**Notice of Allowability**

10/813,769

LIEN TM NGO

DEAN ET AL.

FIG. 3A

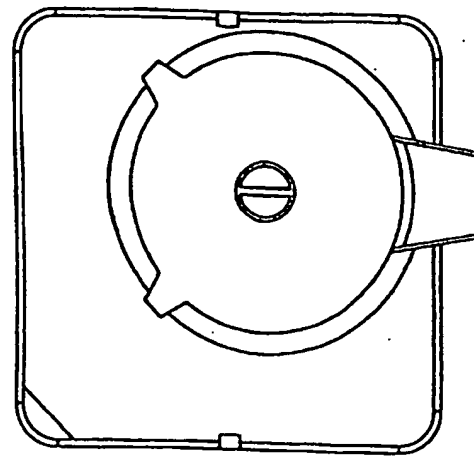
-- PRIOR ART -- has been added in FIGS. 3A, 3B, 4A, 4B, 10 and 10A.
